# Generic design assessment UK EPR nuclear power plant design by AREVA NP SAS and Electricité de France SA

**Assessment report  
Best available techniques to  
prevent or minimise creation  
of radioactive wastes**

### UK EPR nuclear power plant design by AREVA NP SAS and Electricité de France SA

#### Assessment report – best available techniques to prevent or minimise the creation of radioactive waste

PCERsc6.4s1 Figure 1:

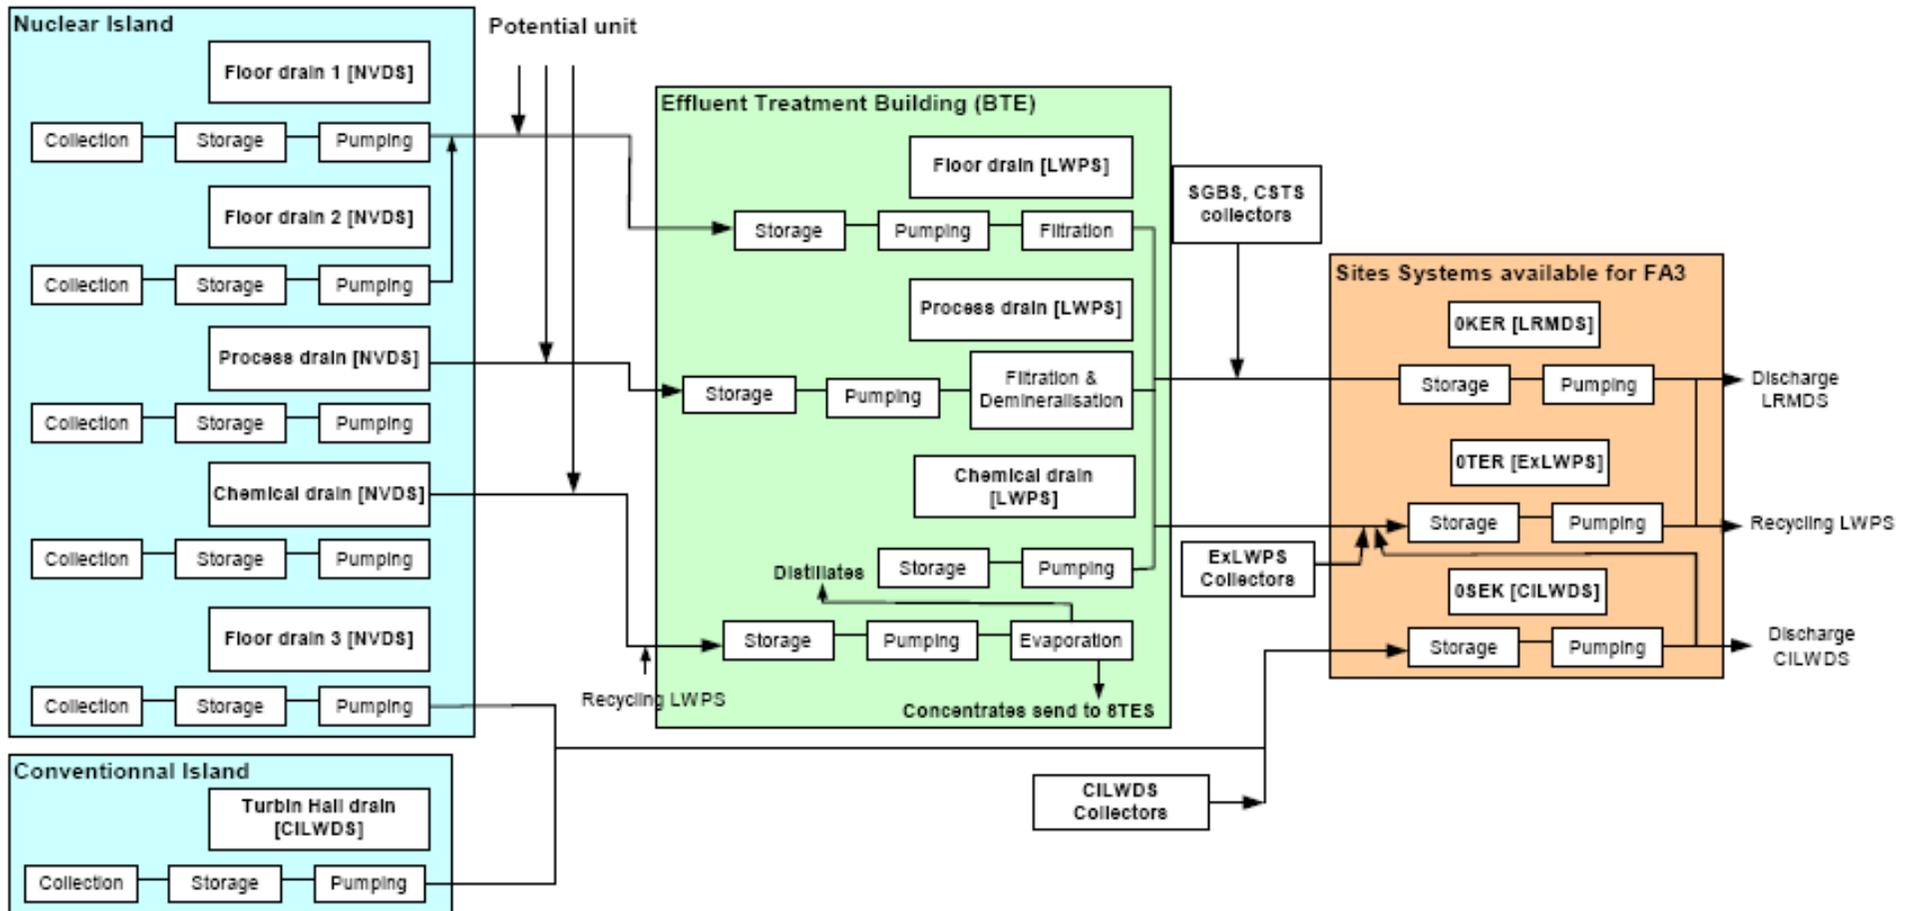
- 144 The NVDS collects all other liquid effluents in a number of drains but maintains segregation to allow the most appropriate treatment before disposal, see PCERsc6.4s1 Figure 1, reproduced in the Annex of this report.

PCERsc6.4s2.1 Figure 2:

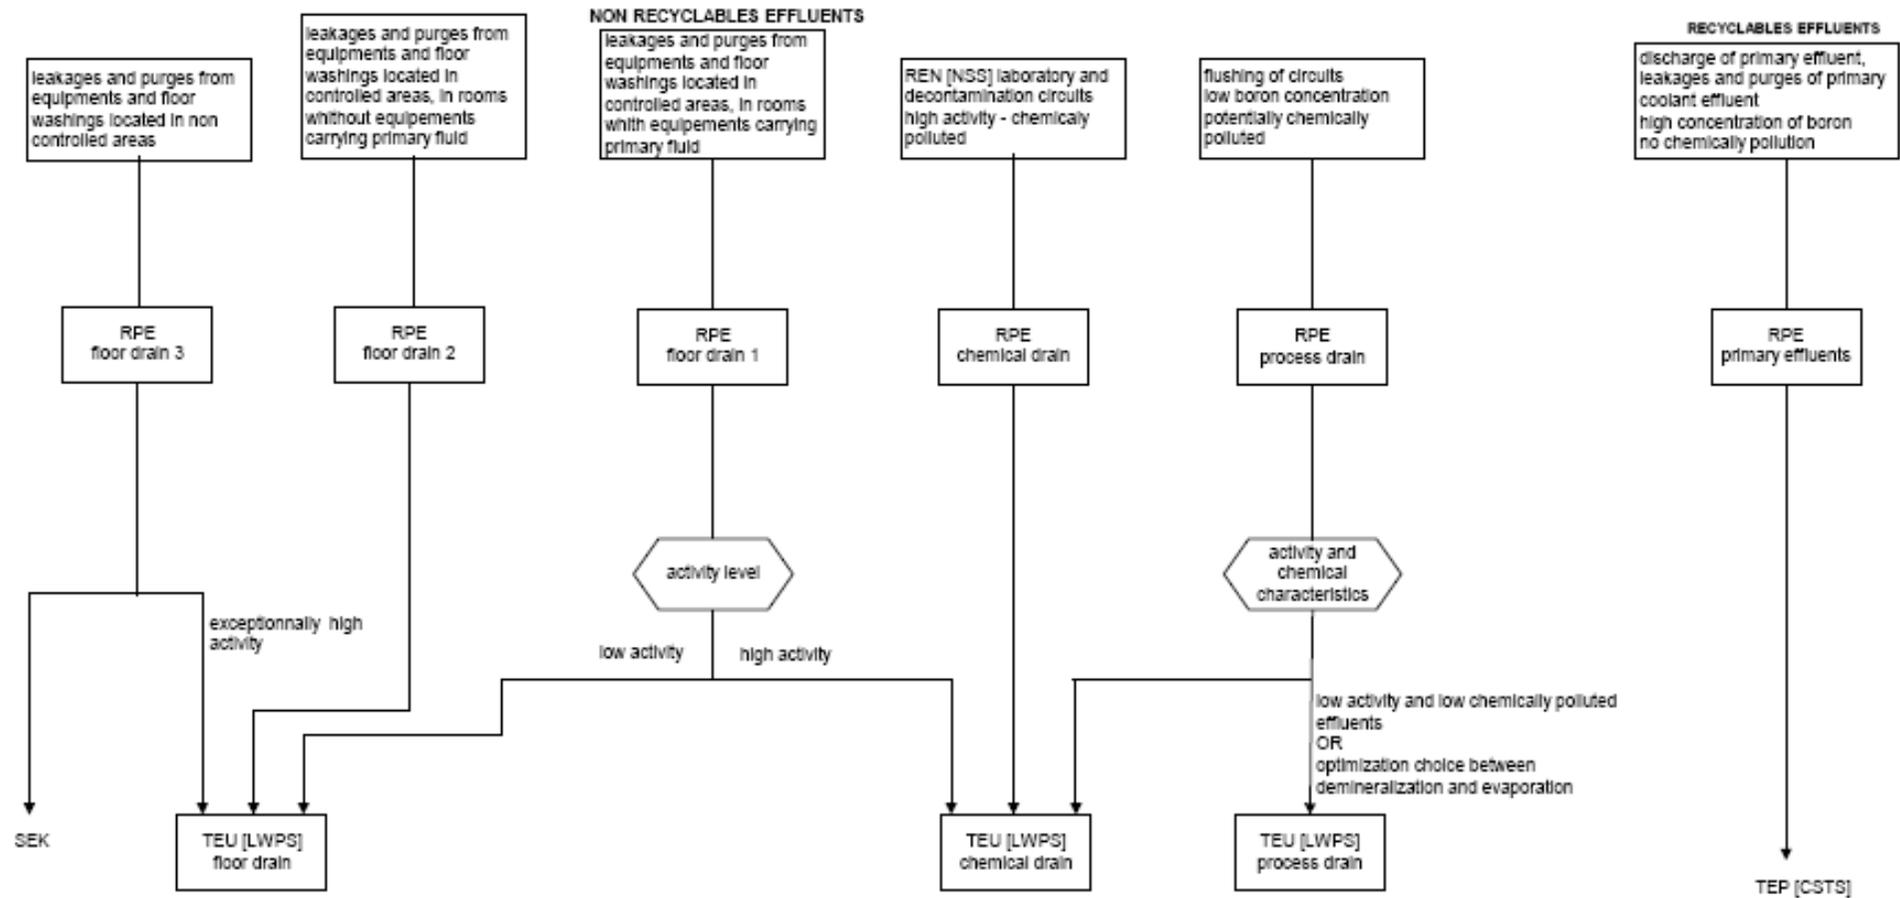
- 145 PCERsc6.4s2.1 Figure 2 (reproduced in the Annex of this report) shows the principle of routing of effluents. Choices can be made at effluent collection sumps as to route, with uncontaminated effluent sent directly to a discharge tank or contaminated effluent to an appropriate tank at the front end of the Liquid Waste Processing System. Again we see this as BAT as it allows the most effective treatments to be applied to minimise activity on disposal.

PCERsc6.2s1.2.3.2 Figure 10

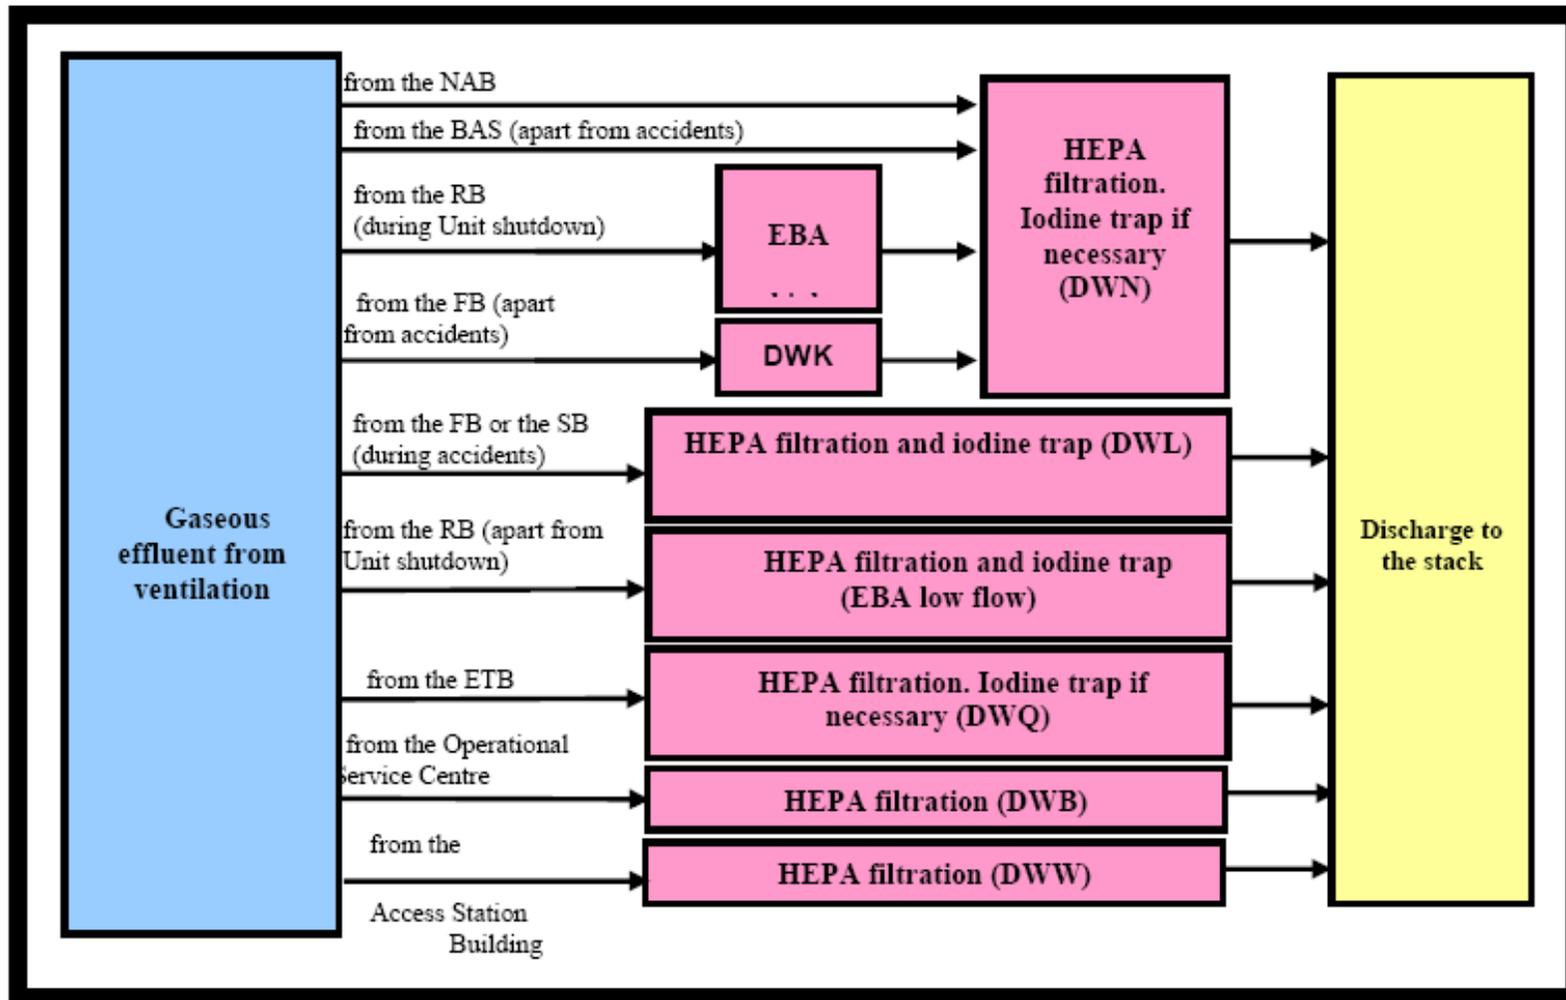
- 148 All radiation controlled areas within the UK EPR are served by ventilation systems (PCERsc6.2s1.2.3.2 Figure 10 – reproduced in the Annex of this report). This is considered to be ALARP to minimise radiation exposure to the workforce. Radioactive materials can occur in the ventilation air from trace leakage from active systems, EDF and AREVA claim “reinforced leak-tightness requirements”(PCERsc8.2s3.3.1), see paragraph 141 above.
